STAFF REPORT
(Preliminary Plat)

CASE NUMBER: SUB 2000-10 -- BENCOR 2ND ADDITION

LOCATION: Southeast corner of 13th St. North and Waco

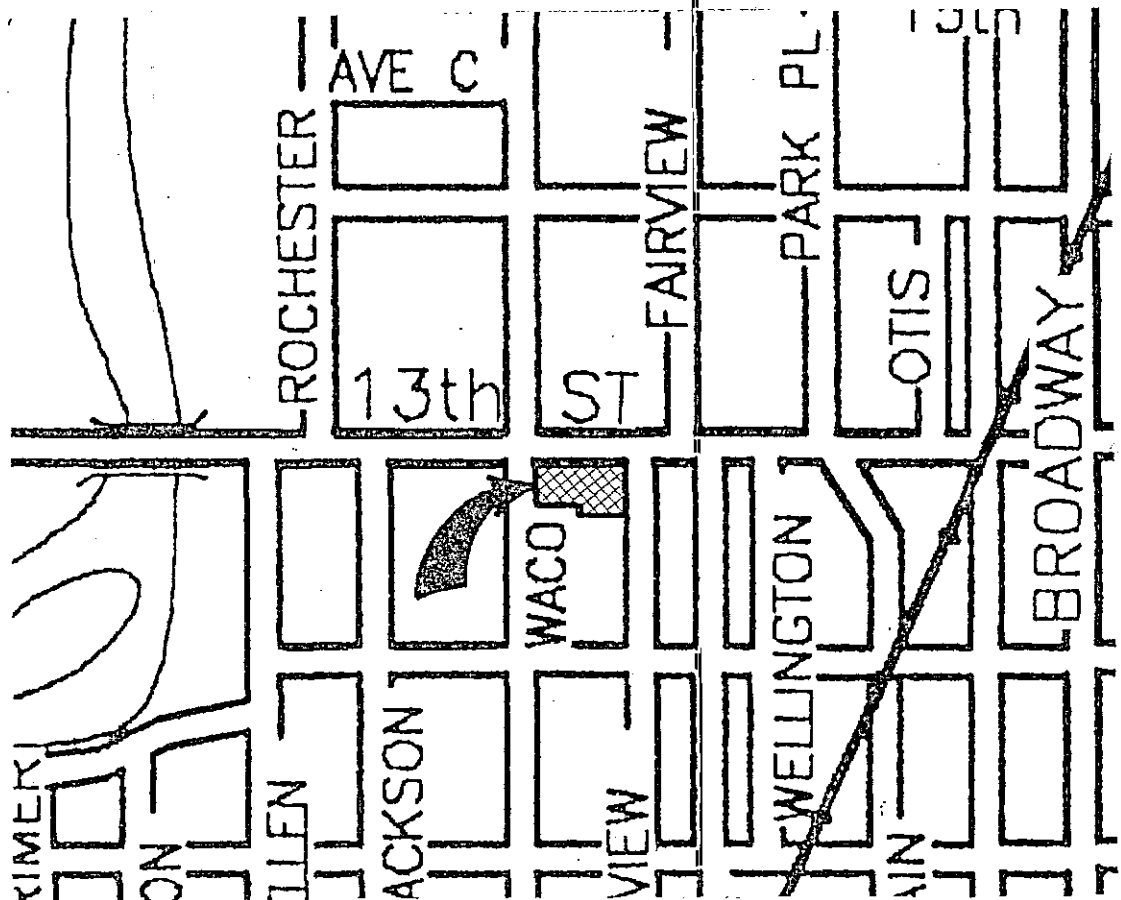
*Drainage improvement
at time of site development
guaranteed. SS abandonment.
Temp. easement to cover SS line.*

UTILITY PLAN
BENCOR 2ND ADDITION
WICHITA, SEDGWICK COUNTY, KANSAS

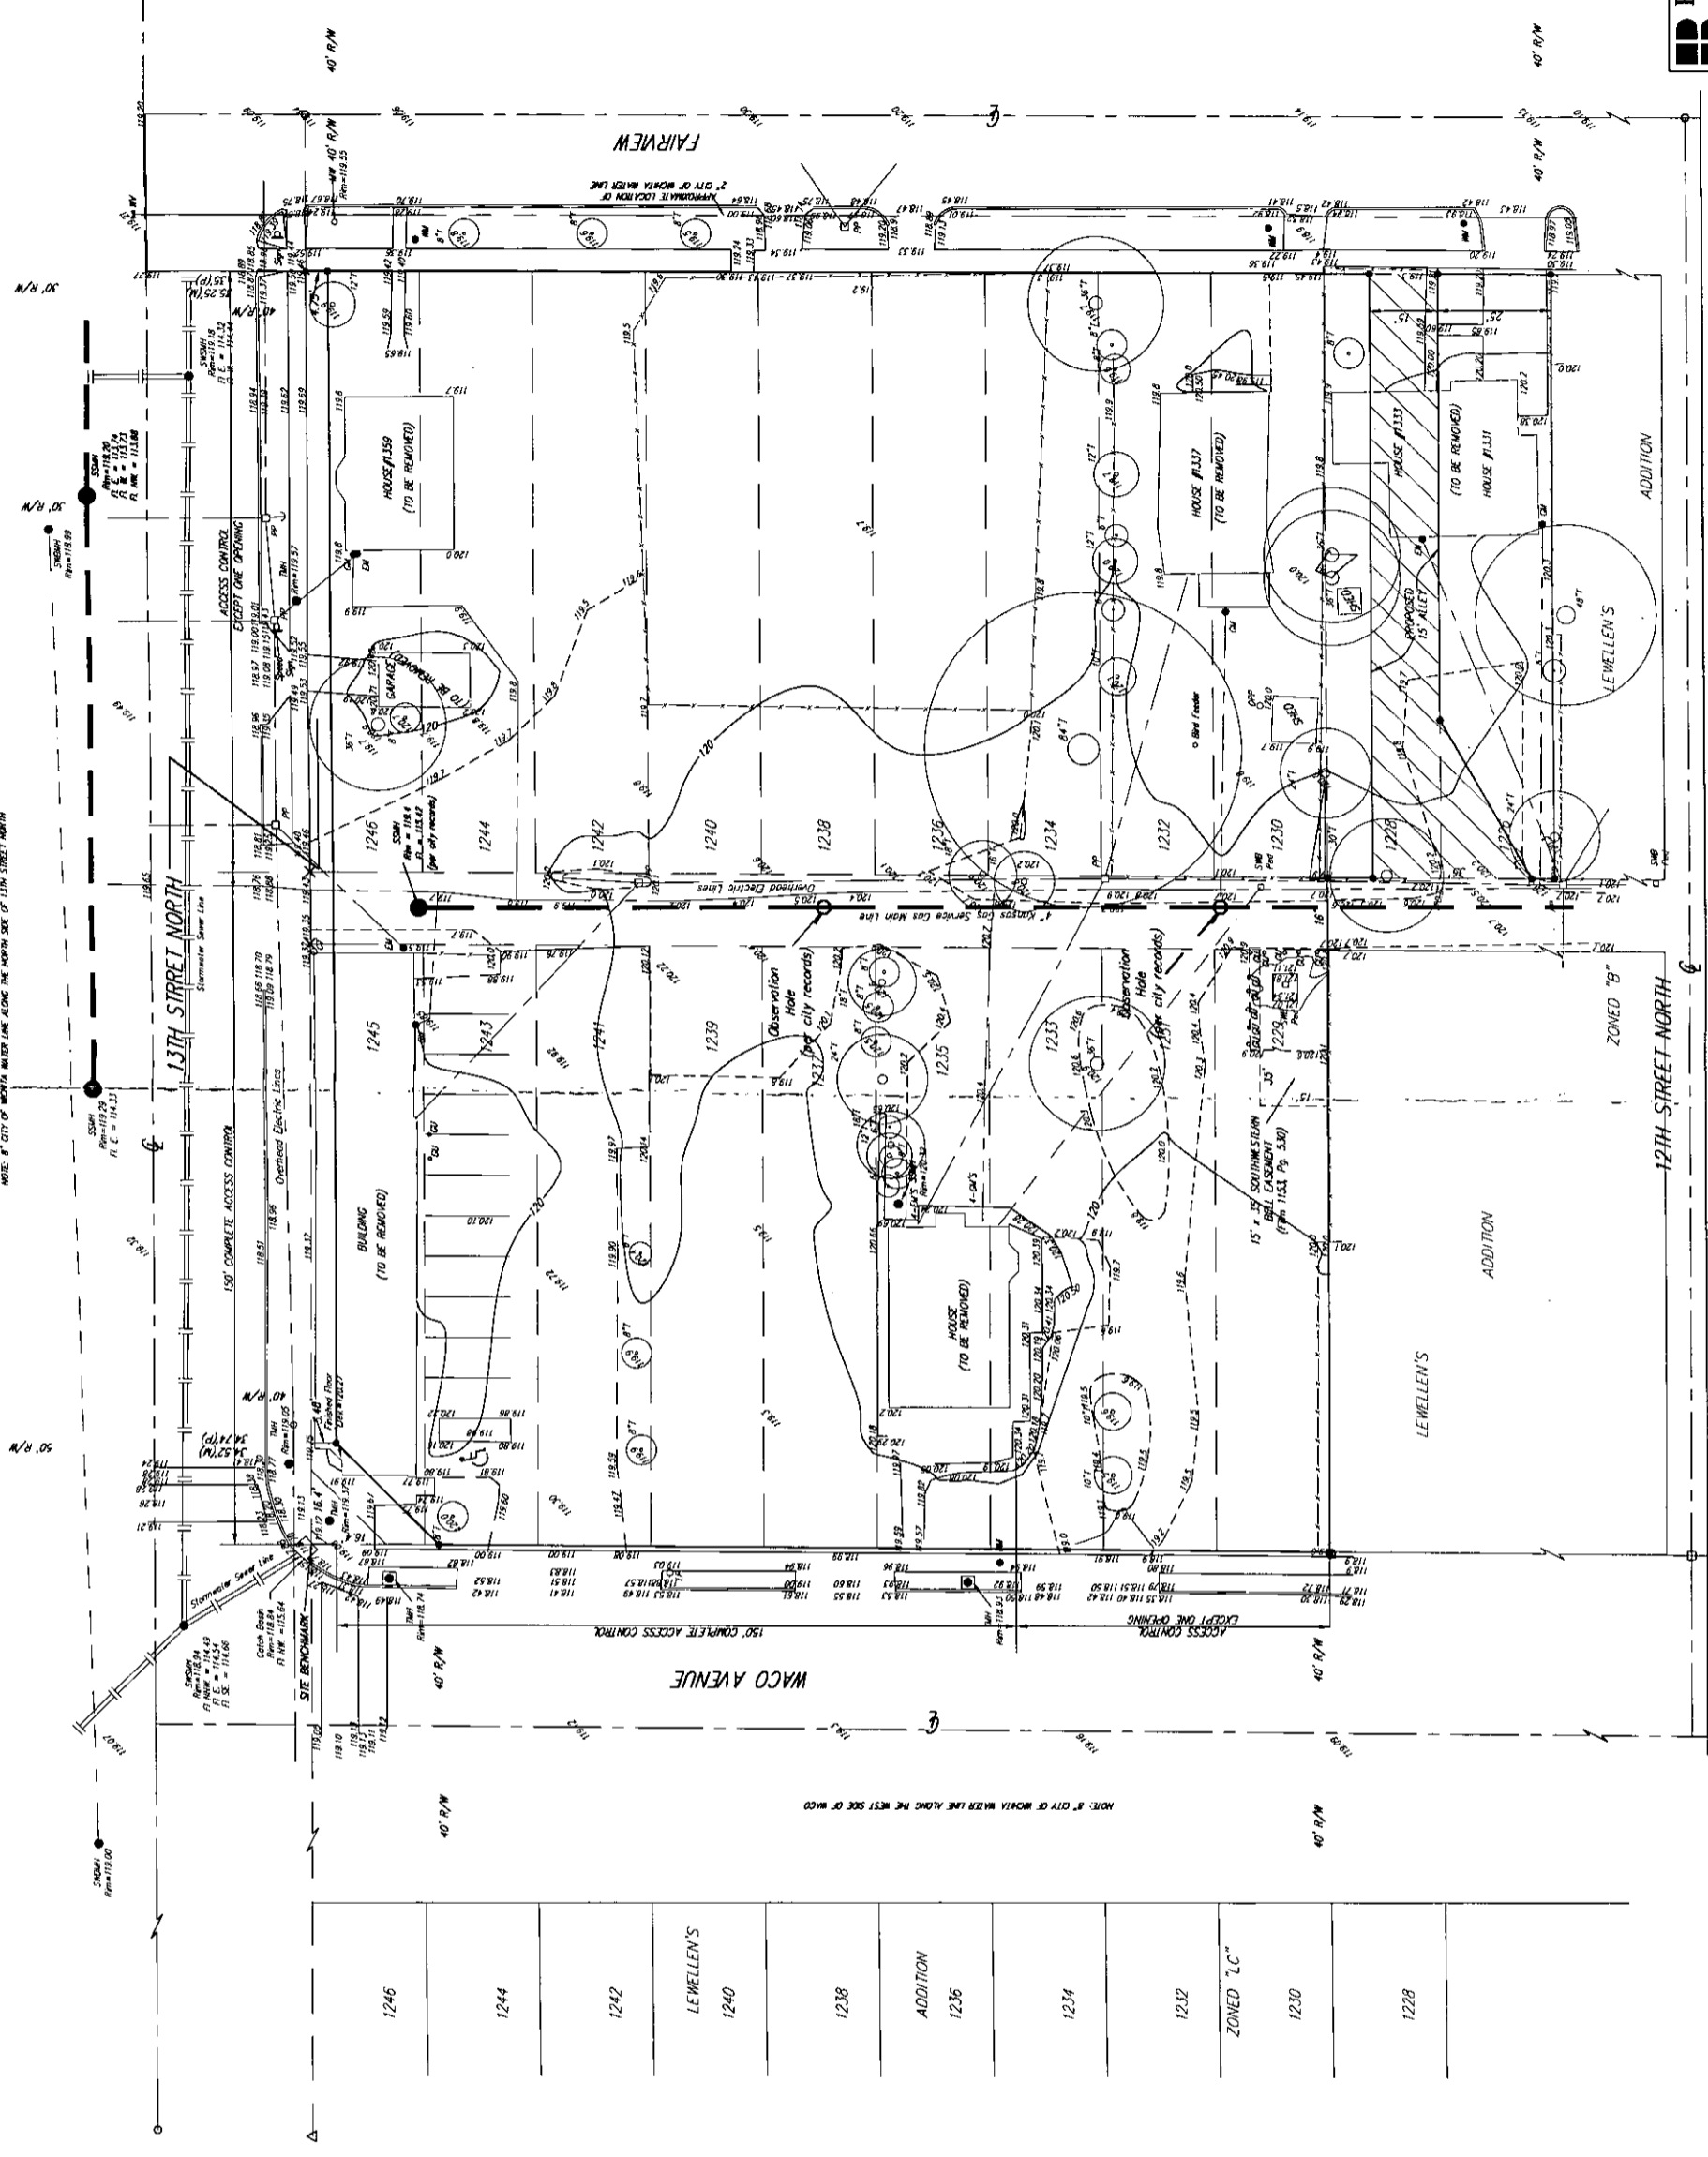
18' Alley Pav.

- A. Municipal services are available to serve the site. City Engineering needs to comment on the need for any easements or guarantees. A guarantee shall be submitted for abandonment of the existing sewer line. A temporary easement should be established to cover the sewer line until abandonment.

- F. Traffic Engineering needs to comment on the need for additional right-of-way for 13th St. North or Waco. A 50-ft half-street right-of-way is typically required for arterials. Traffic Engineering has approved a 40-ft half-street right-of-way. Contingent R/W?

- S. The representatives from the utility companies should be prepared to comment on the need for any additional utility easements to be platted on this property. Southwestern Bell requests that the vacated alley be retained as a utility easement. Any relocation or reconstruction of utilities made necessary by this plat shall be the responsibility of the Applicant.
